WF40 - Retrofitting Additional Fastening Bolt and Line Bracket for Coolant Pipe (Workshop Campaign)

Vehicle Type: **918 Spyder**

Model Year: **2015**

Concerns: **Coolant pipe to reservoir for medium/low-temperature cooling system**

Installation position of coolant pipe

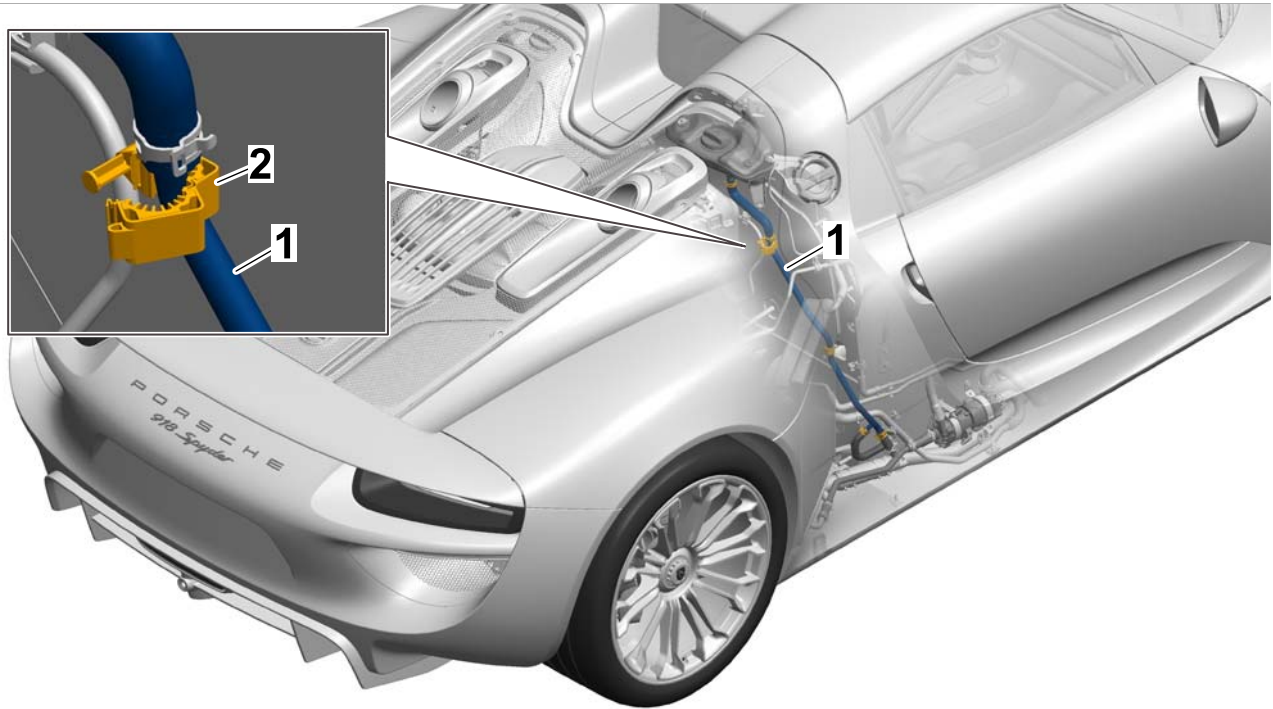
Issue: **There is a possibility that the coolant pipe for the right coolant reservoir is rubbing against the engine mount as a result of relative movements of the engine in the event of unfavourable tolerances on the affected vehicles.**

- 1 – Coolant pipe for coolant reservoir on the right (**check**)
- 2 – Line bracket (**retrofit**)

- Action Required:
- Retrofit additional fastening bolt and line bracket for the coolant pipe
 - Check coolant pipe for damage in the engine mount area
 - Replace the coolant pipe if necessary, depending on the result of the check

Drilling additional bore

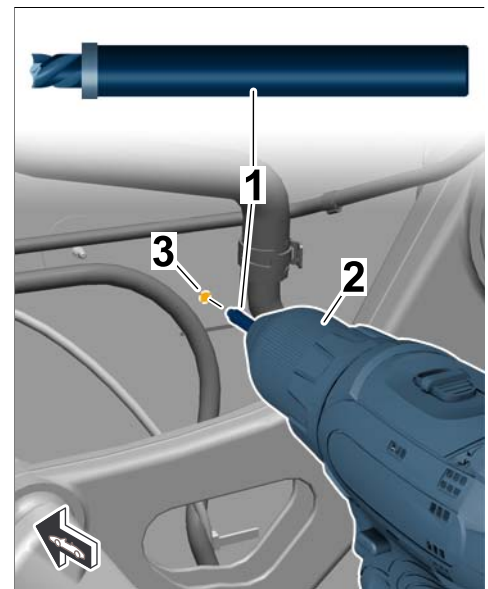
NOTICE**Drilling work not performed correctly on the monocoque**

- 3.2 Drill the additional bore at the marked position
⇒ *Drilling additional bore -3- only* using the **drill attachment with bit stop** ⇒ *Drilling additional bore -1-* from the set of fastening parts and a hand drill ⇒ *Drilling additional bore -1-*.

While drilling, make sure in particular to make the bore hole at a right angle to the monocoque and as far as the bit stop on the drill attachment. Remove any carbon fibre-reinforced plastic dust with a vacuum cleaner.

- 3.3 De-burr additional bore ⇒ *Drilling additional bore -3-* in the monocoque rear wall using suitable sandpaper. Sand an area of approx. 10 mm around the bore on the monocoque rear wall.

Installing additional line bracket

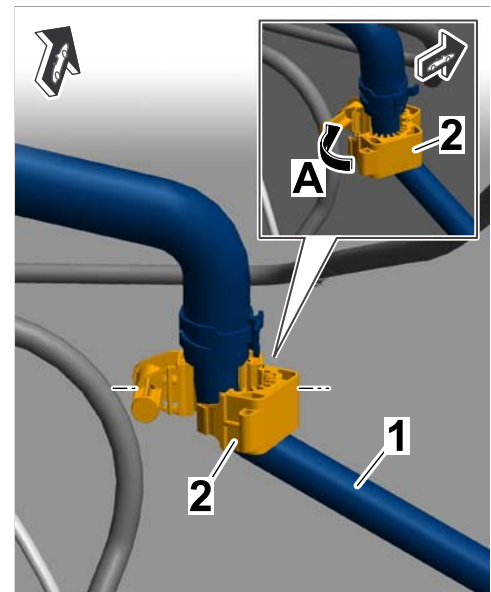
- 6 Secure the coolant hose on the monocoque rear wall.

6.1 Screw additional line bracket ⇒ *Installing additional line bracket -2-* as far as it will go onto the previously bonded fastening bolt and align it horizontally as shown.

6.2 Insert coolant pipe ⇒ *Installing additional line bracket -1-* for the right coolant reservoir without tension in the line bracket ⇒ *Installing additional line bracket -2-* and lock the line bracket ⇒ *Installing additional line bracket -A-*.
